AMENDMENTS TO THE DRAWINGS:

REMARKS

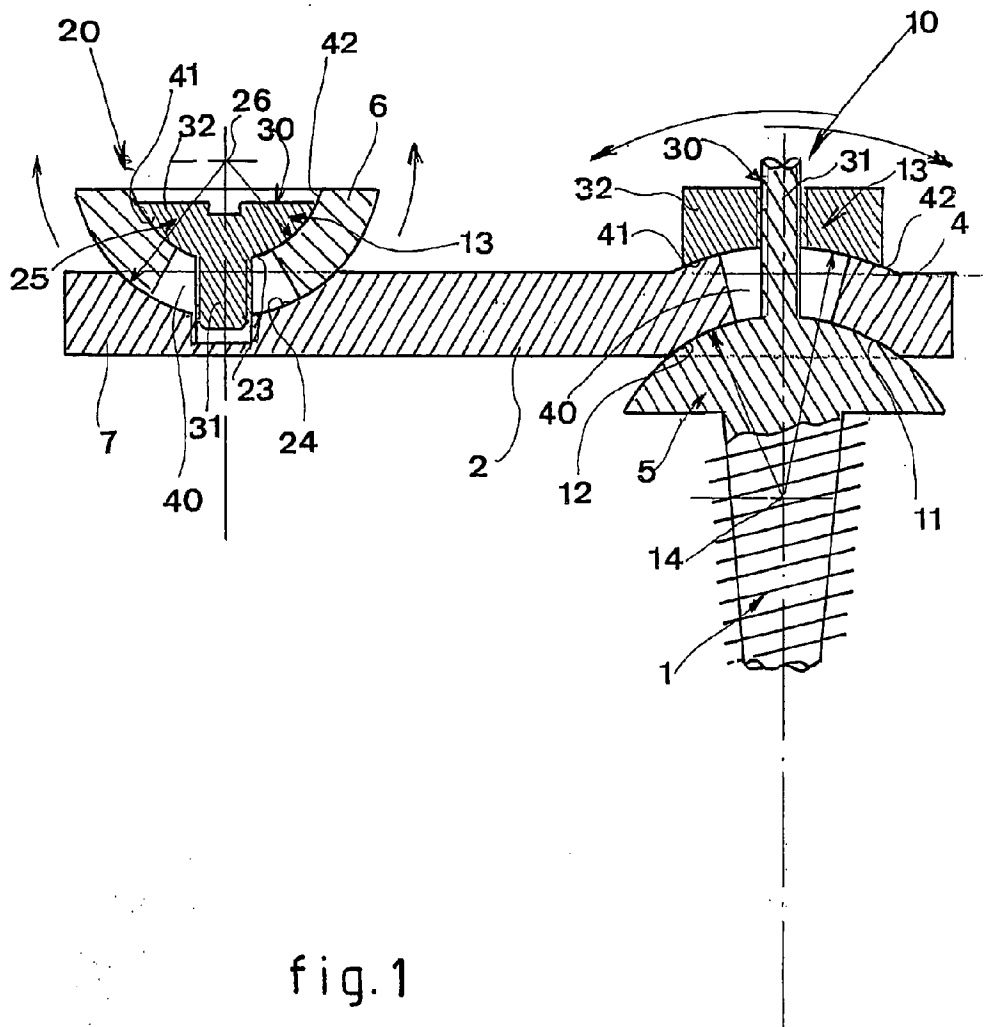
A replacement drawing is submitted for Figure 1 adding the symbol "'" to elements 30, 31, 32, 40, 41 and 42 on the left-hand side of the figure to distinguish these elements from those on the right-hand side of the figure.

A replacement drawing is submitted for Figure 1 adding the symbol "'" to elements 30, 31, 32, 40, 41 and 42 on the left-hand side of the figure to distinguish these elements from those on the right-hand side of the figure. Although the terminology used in the specification is the same, nevertheless, the above-noted elements are directed to a different embodiment as disclosed on page 4, line 21 to page 5, line 4. The above change is the only change and is believed not to introduce new matter.

By way of example, Figure 1 of the present application, reproduced below shows screwing head 32 is screwed onto said threaded shank 31. Faces of the screwing head 32 (face 41) and of a hemispherical portion (unnumbered having face 42) that comes into contact with the screwing head are of complementary hemispherical shapes.

By way of example, Figure 1 of the present application, reproduced above, shows face 41 of the screwing head 32 on the right-hand side of the figure and face 42 of the hemispherical portion that comes into contact with the screwing head 32 are respectively concave and convex.
